FED. ROAD DIST. NO.	STATE	FED. AID PROJ. NO.	FISCAL YEAR	SHEET NO.	TOTAL SHEETS
HAWAII	HAW.	I-H3-I(61)	1990	281	424

HALAWA APPROACH

HAIKU APPROACH

DATE	REVISION
8/6/92	REVISED DOMESTIC WATER GPM AND SANITARY GPM & TANK SIZE PER DCN61-031
4/26/90	DELETED NOTE: 25 GPM FROM CONTROL BUILDING
STATE OF HAWAII DEPARTMENT OF TRANSPORTATION HIGHWAYS DIVISION WATER BALANCE DIAGRAM STANDARDS INTERSTATE ROUTE H-3 F.A.I. PROJ. NO. I-H3-I(61)	
SCALE: NONE	DATE: JAN 1990
SHEET NO. M2	OF 8 SHEETS

- NOTE:
- FOR STRUCTURAL DETAILS OF VALVE STATION AND VALVE BOX SEE SHEET NO. ST8.
 - SEE SHEET NO. C9 FOR LOCATION OF FIRE WATER LINE.
 - SEE SHEET NO. C12 FOR DETAILS OF INSULATION FLANGE.

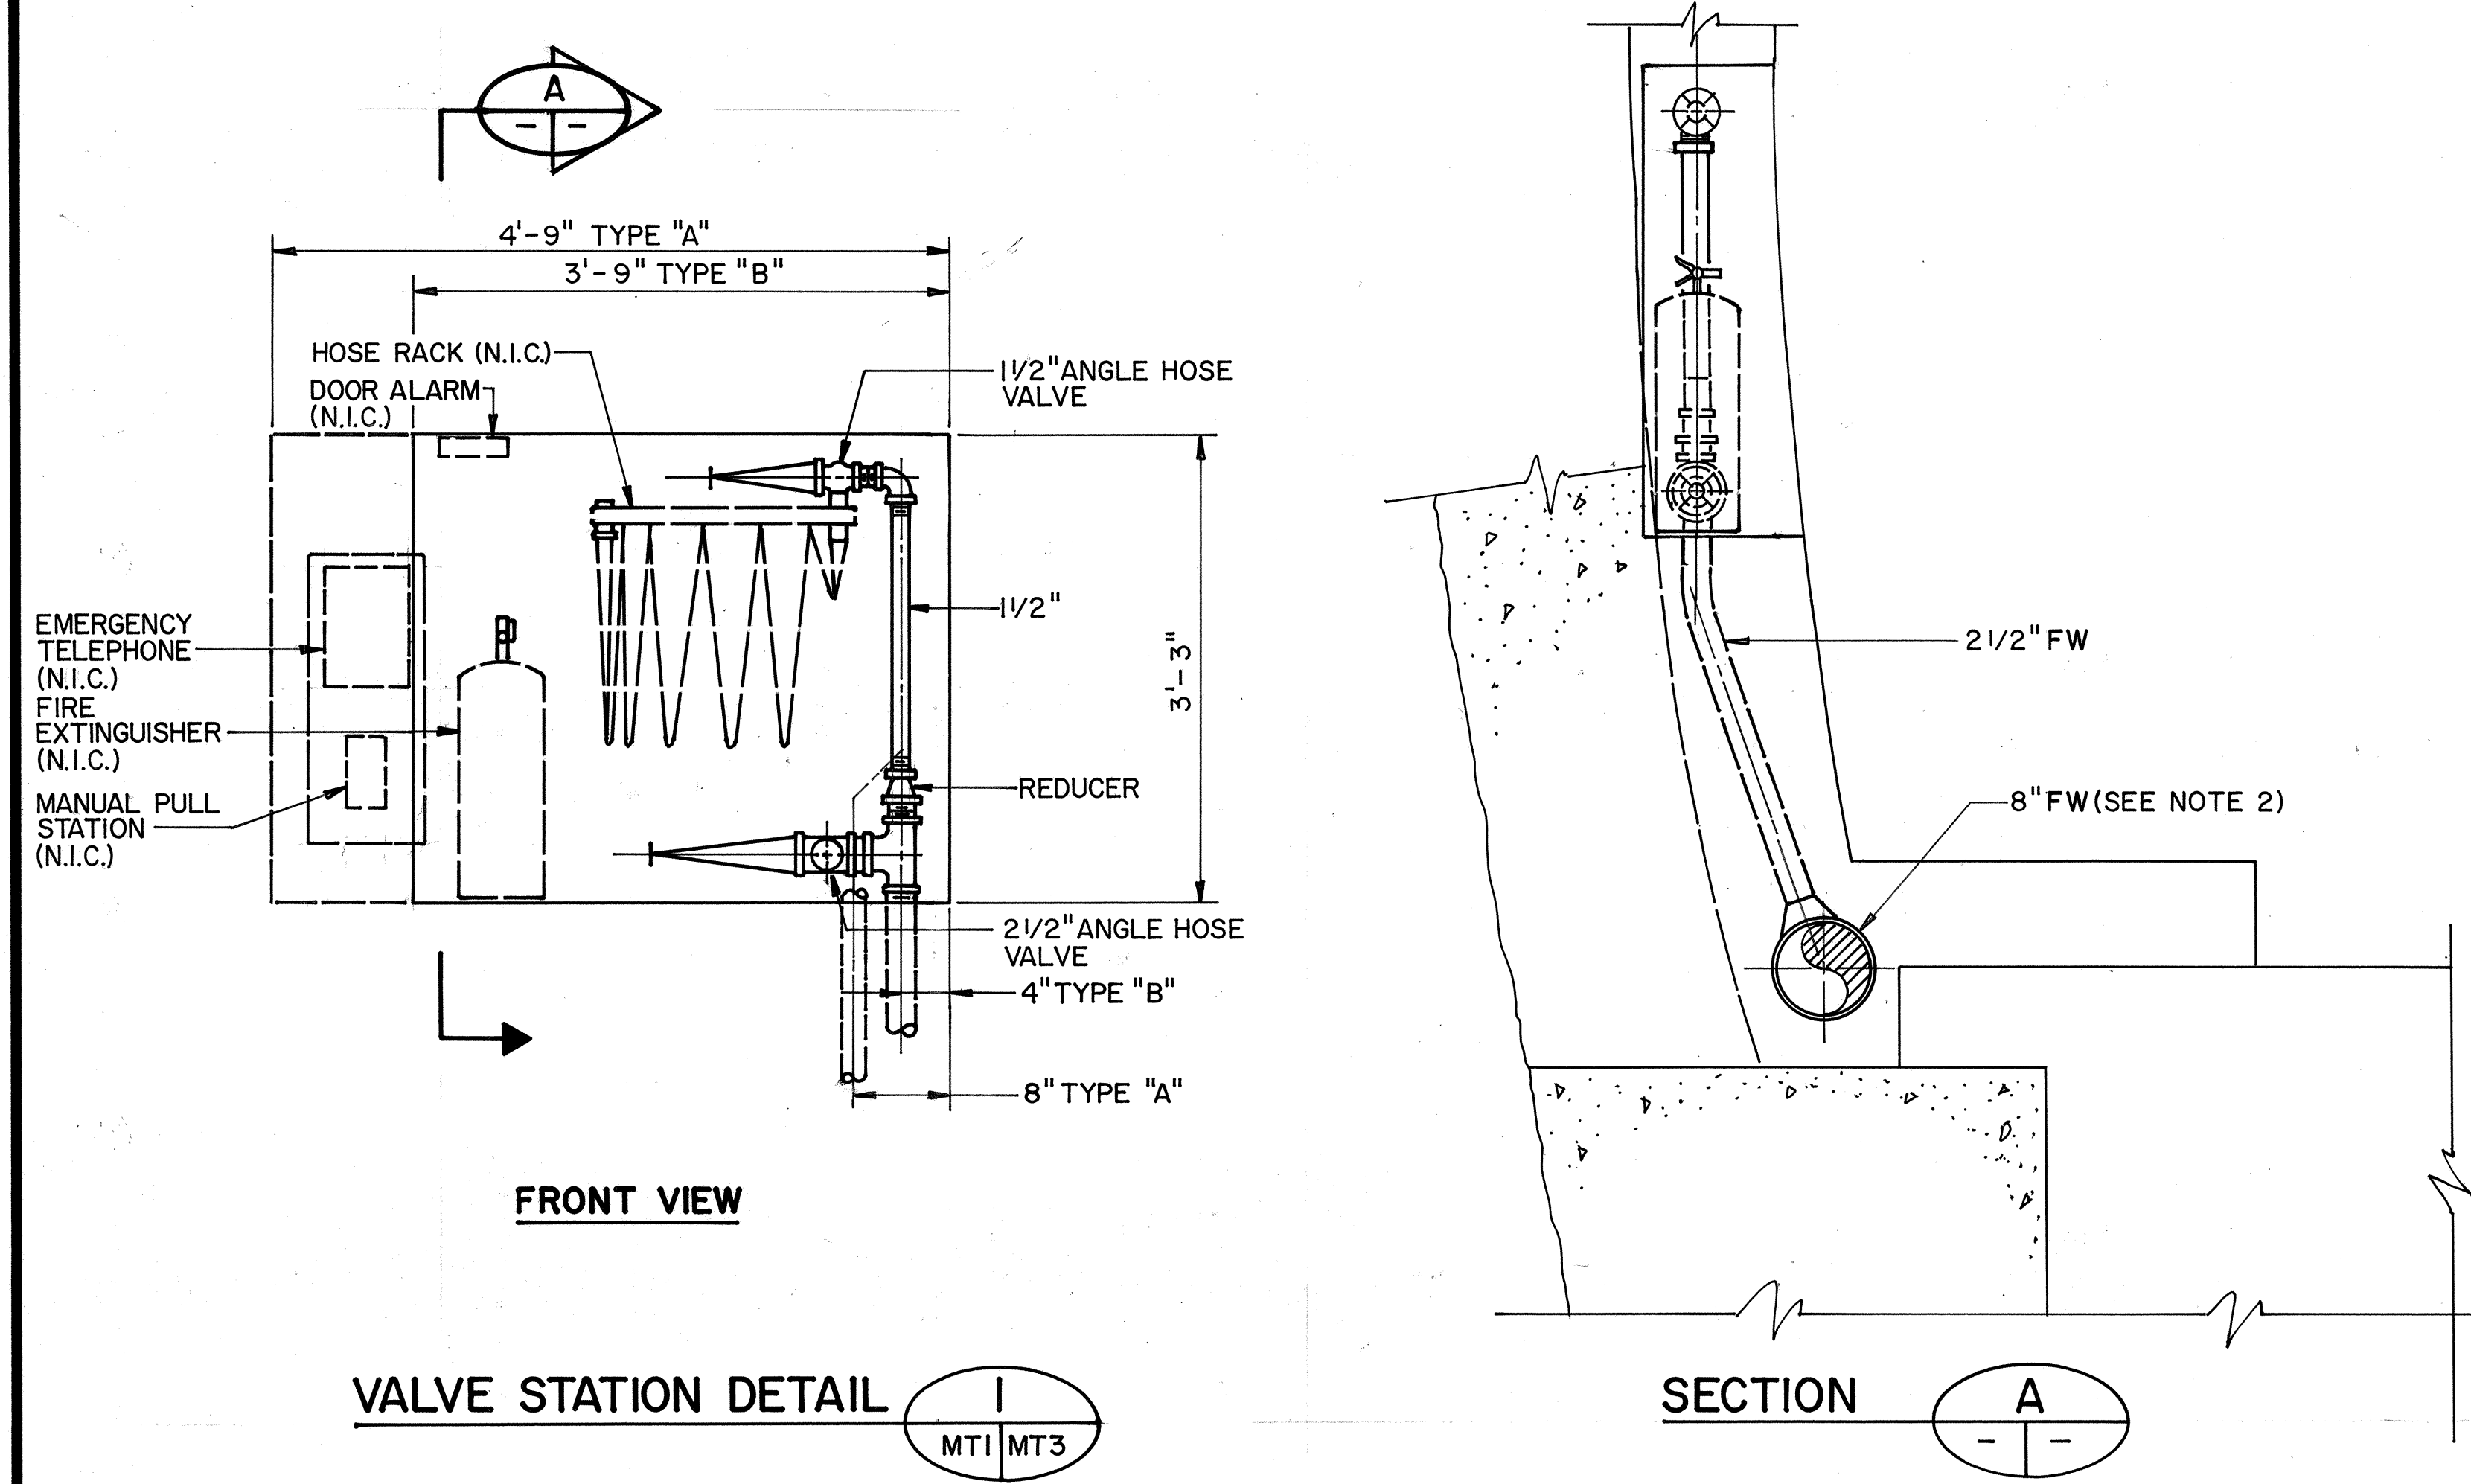
DATE	REVISION
4/26/90	REVISED 8" WSP TO 8" FW & IDENTIFIED THREADED FLANGES.
DATE	REVISION
STATE OF HAWAII DEPARTMENT OF TRANSPORTATION HIGHWAYS DIVISION FIRE PROTECTION - SECTIONS AND DETAIL HAIKU TUNNELS INTERSTATE ROUTE H-3 F.A.I. PROJ. NO. I-H3-1(61)	
SCALE: 1"=1'-0" DATE: JAN 1990 SHEET NO. MT3 OF 3 SHEETS
